ADDENDUM NO. 1

**Sedgwick County Project: Charlotte Pipe Addition
Left Turn Lane Improvements**

ENTRANCE DETAILS

PLAN (TYPE I)
STA. 50+00.00 (LT.)

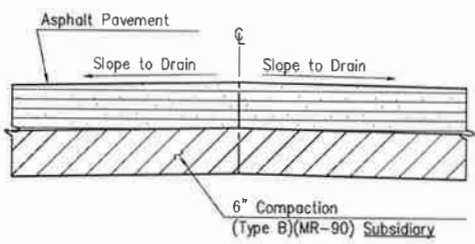
- Replace Sheet No. 7 with Sheet No. 7R.; Changed 6" concrete to 8" concrete in the Type I detail.
